NAVIGATION - STALL WARNING HORN REPLACEMENT

The original stall warning horn is no longer available. If the stall warning horn needs to be replaced, a new stall warning horn is available and will require an additional bracket for installation.

MEB-34-07
Page 1 of 29

Figure 1. Before Modification (Sheet 1)

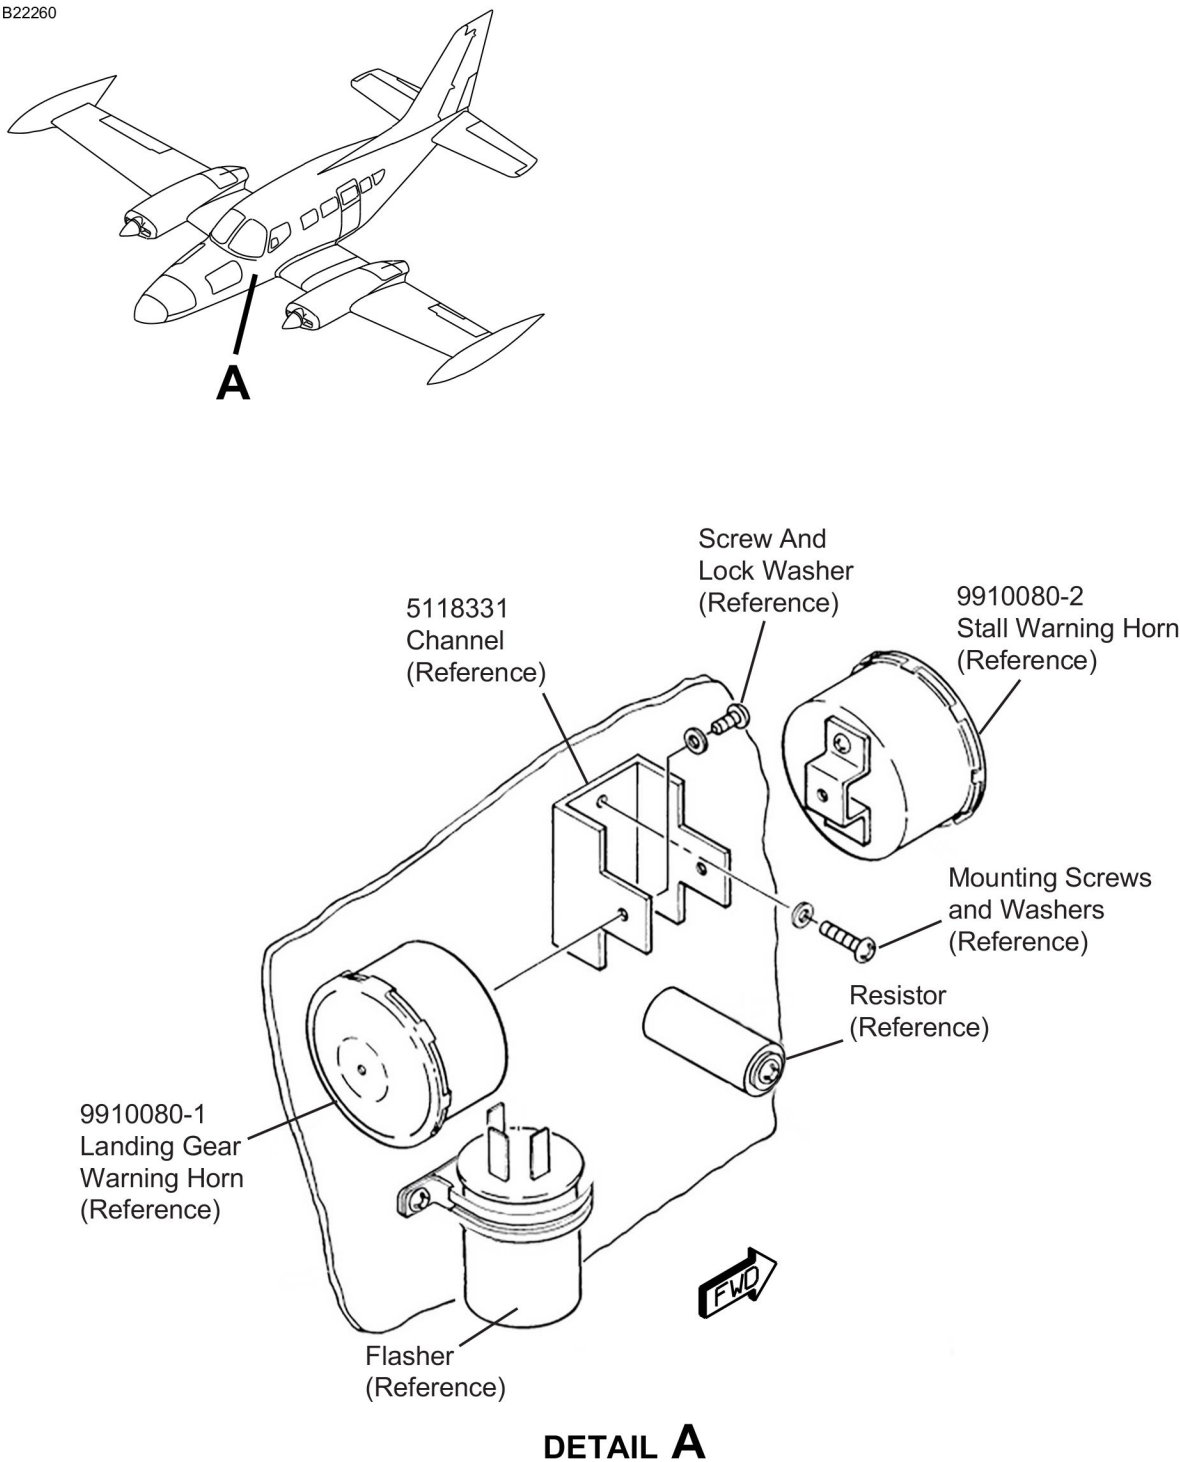
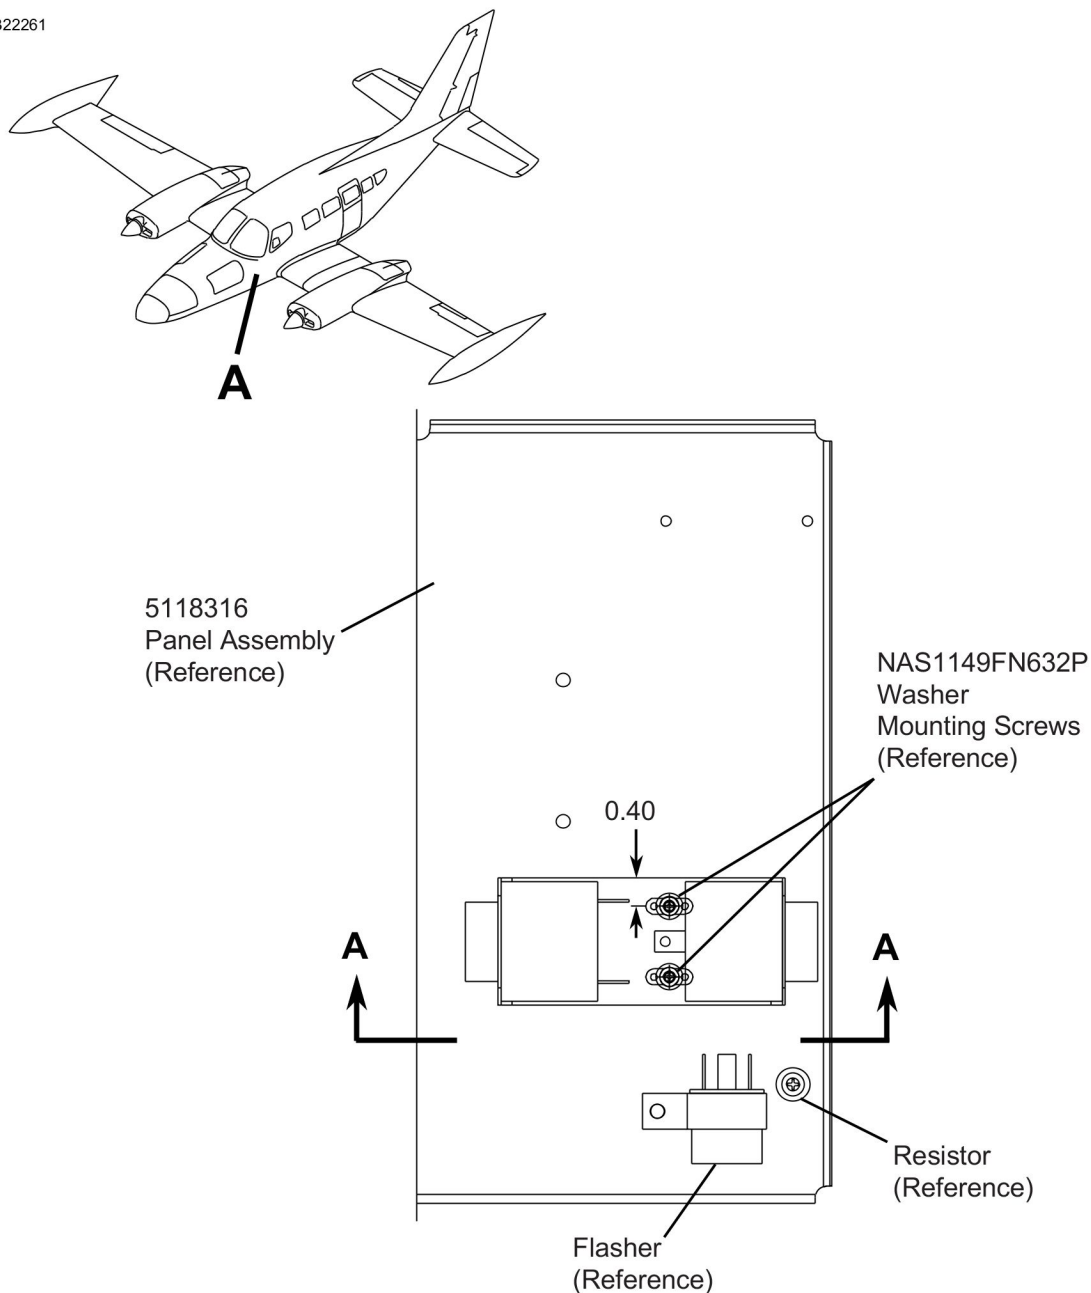
3. (Refer to Figure 1, Sheet 1.) Remove the 9910080-2 Stall Warning Horn as follows:
 - A. Remove and discard the screw and lock washer from the 9910080-1 Landing Gear Warning Horn.
 - B. Disconnect and label the electrical wiring from the 9910080-1 Landing Gear Warning Horn.
 - C. Discard all electrical hardware from the 9910080-1 Landing Gear Warning Horn.
 - D. Discard the 9910080-1 Landing Gear Warning Horn.
 - E. Remove and discard the screw and lock washer from the 9910080-2 Stall Warning Horn.
 - F. Disconnect and label the electrical wiring from the 9910080-2 Stall Warning Horn.
 - G. Discard all electrical hardware from the 9910080-2 Stall Warning Horn.
 - H. Discard the 9910080-2 Stall Warning Horn.
 - I. Remove and keep the two mounting screws from the 5118331 Channel.

10. (Refer to Figure 1, Sheet 1.) Remove the 9910080-2 Stall Warning Horn as follows:
- A. Remove and discard the screw and lock washer from the 9910080-2 Stall Warning Horn.
 - B. Disconnect and label the electrical wiring from the 9910080-2 Stall Warning Horn.
 - C. Discard all electrical hardware from the 9910080-2 Stall Warning Horn.
 - D. Discard the 9910080-2 Stall Warning Horn.
 - E. Remove and keep the screw and lock washer from the 9910080-1 Landing Gear Warning Horn.
 - F. Keep the 9910080-1 Landing Gear Warning Horn.

Figure 2. Group A Configuration 1 (Sheet 1)

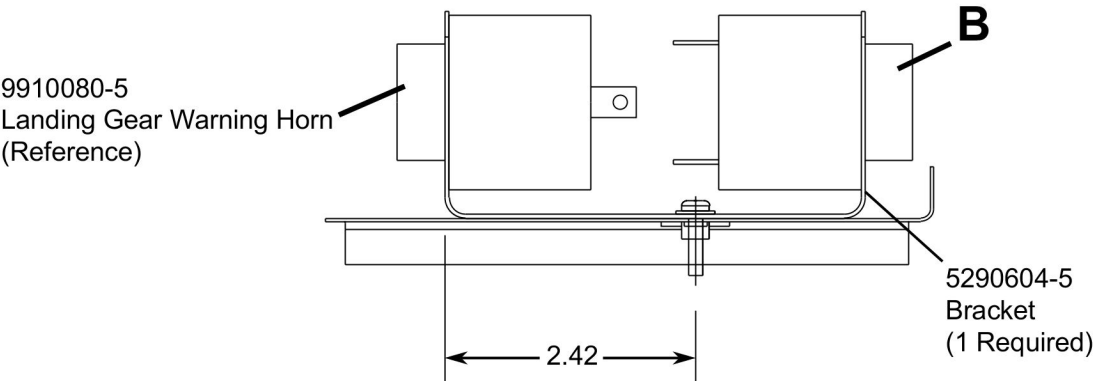
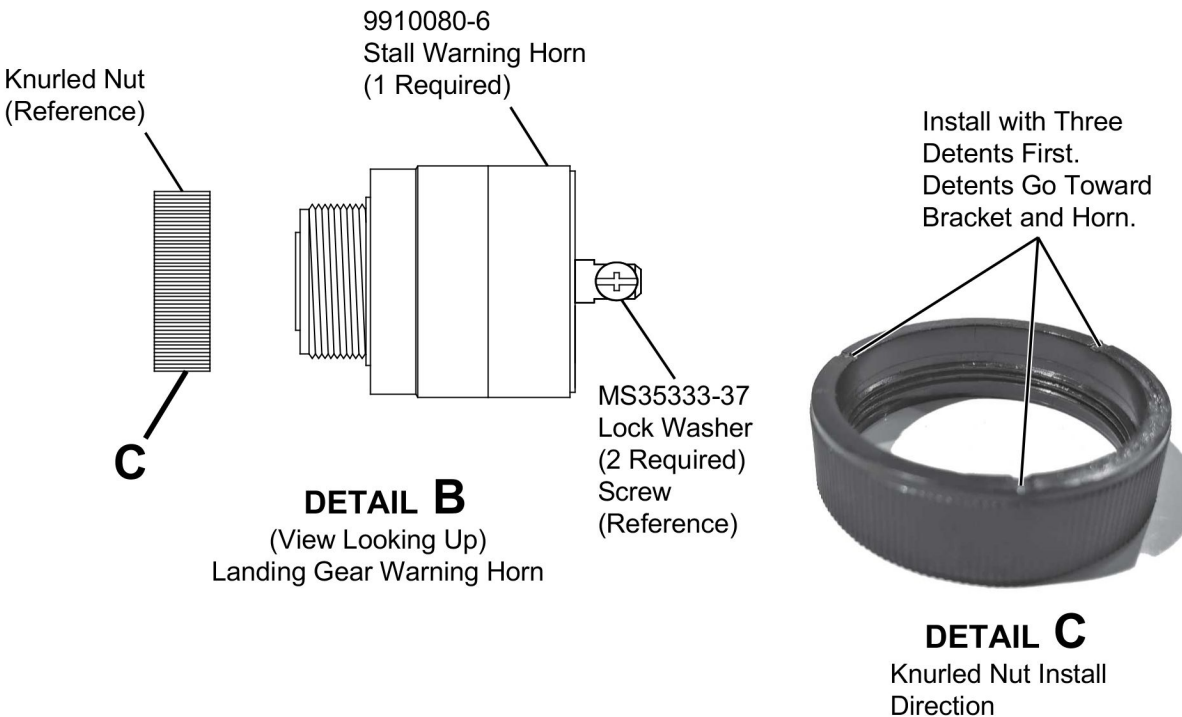
4. (Refer to Figure 2, Sheet 1 and 2.) Install the 9910080-6 Stall Warning Horn as follows:
 - A. Install the 9910080-5 Landing Gear Warning Horn. (Refer to MEB-32-03: Landing Gear Warning Horn Replacement, **CONFIGURATION 1 GROUP A INSTALLATION**.)
 - B. Install the 9910080-6 Stall Warning Horn into the 5290604-5 Bracket.
 - C. Install the knurled nut onto the 9910080-6 Stall Warning Horn.

NOTE: The plastic knurled nut must be installed with the three indents toward the bracket and horn assembly. On the internal circumference, the smooth side without threads is installed first, towards the bracket and horn. This technique of installation will make sure the nut fully seats against the bracket and not bottom-out on the threads. If not installed correctly the knurled nut will bottom-out on the threads and the horn assembly will not be fully tightened in the bracket.
 - D. Install the labeled electrical wiring, screws, and the two MS35333-37 Lock Washers into the 9910080-6 Stall Warning Horn.

Figure 3. Group B Configuration 1 (Sheet 1)

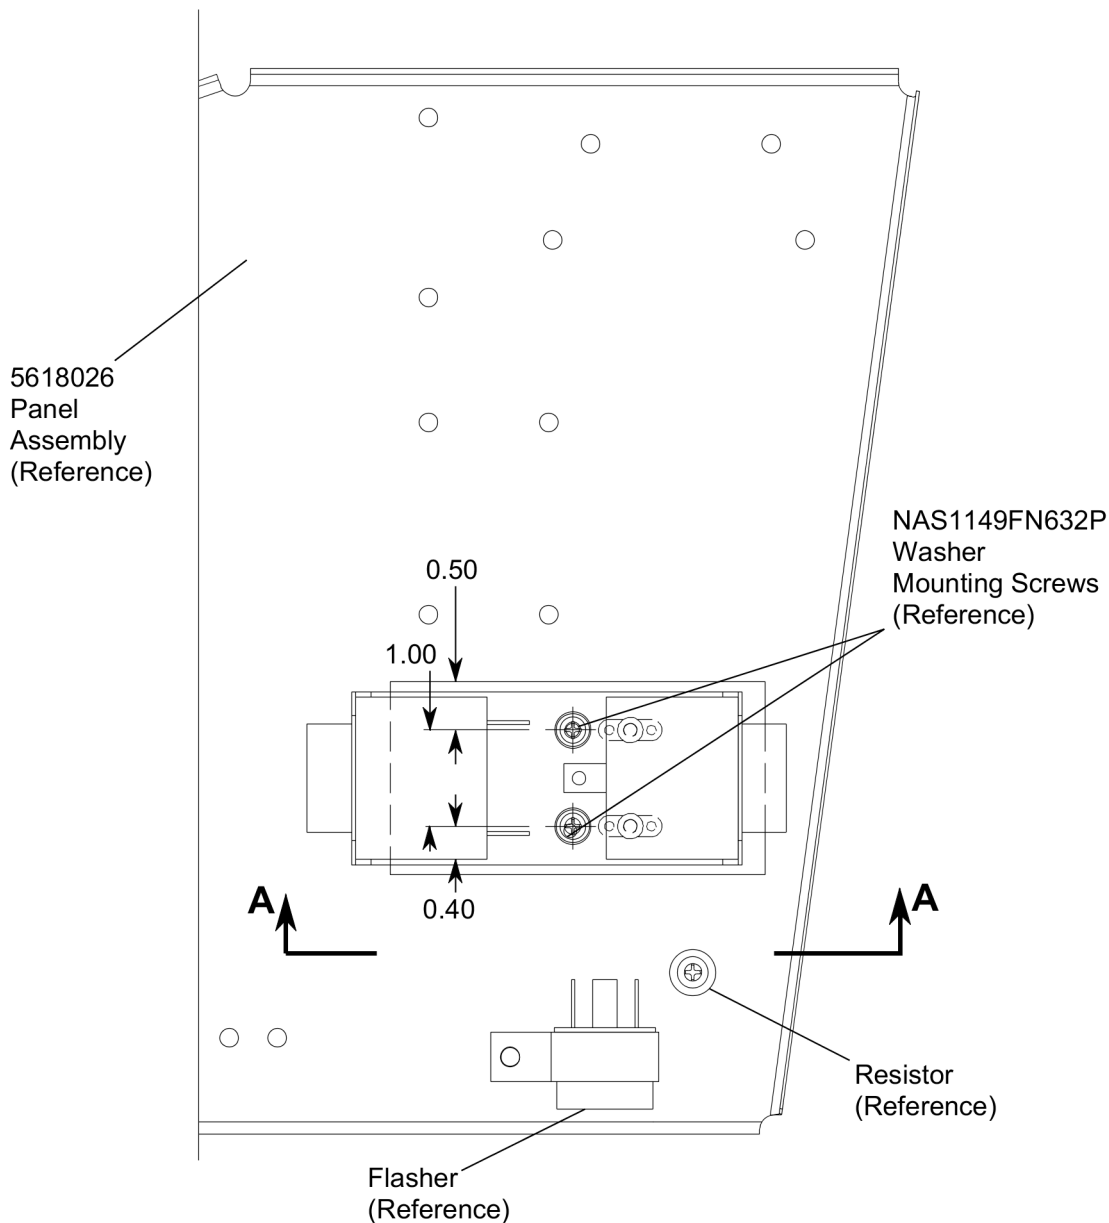
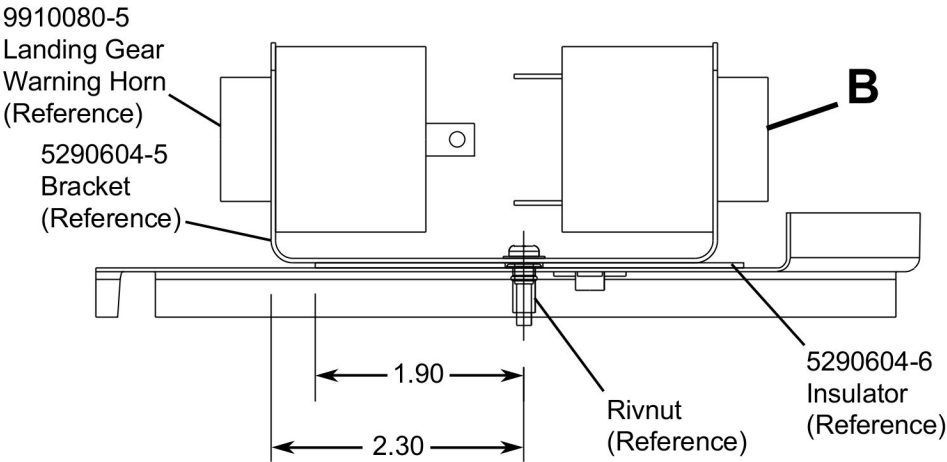
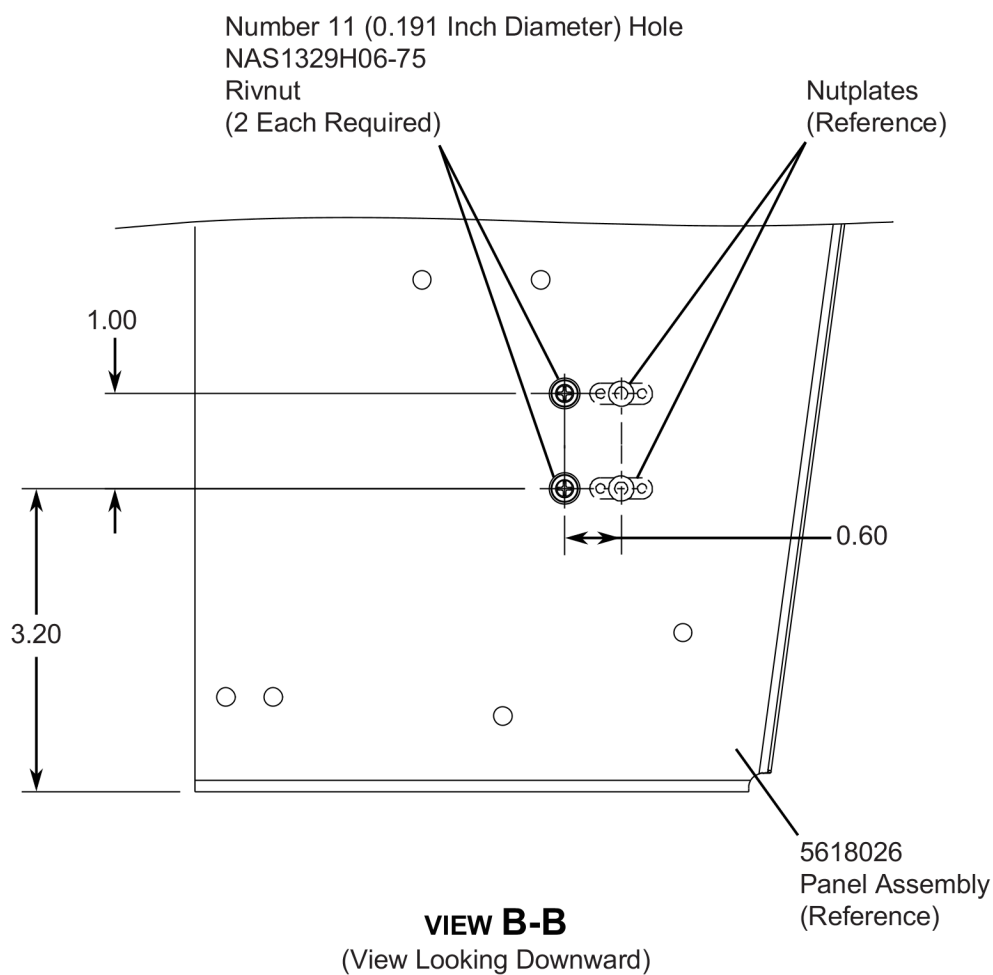
7. (Refer to Figure 3, Sheet 1 and 2.) Install the 9910080-6 Stall Warning Horn as follows:
- A. Install the 9910080-5 Landing Gear Warning Horn. (Refer to MEB-32-03: Landing Gear Warning Horn Replacement, **CONFIGURATION 1 GROUP B INSTALLATION**.)
 - B. Install the 9910080-6 Stall Warning Horn into the 5290604-5 Bracket.
 - C. Install the knurled nut onto the 9910080-6 Stall Warning Horn.

NOTE: The plastic knurled nut must be installed with the three indents toward the bracket and horn assembly. On the internal circumference, the smooth side without threads is installed first, towards the bracket and horn. This technique of installation will make sure the nut fully seats against the bracket and not bottom-out on the threads. If not installed correctly the knurled nut will bottom-out on the threads and the horn assembly will not be fully tightened in the bracket.

16. (Refer to Figure 3, Sheet 3.) Locate and drill the two holes into the 5618026 Panel Assembly as follows:

A. Locate and drill the two Number 11 (0.191 inch diameter) holes into the 5618026 Panel Assembly.

B. Install the two NAS1329H06-75 Rivnuts into the drilled holes of the 5618026 Panel Assembly.
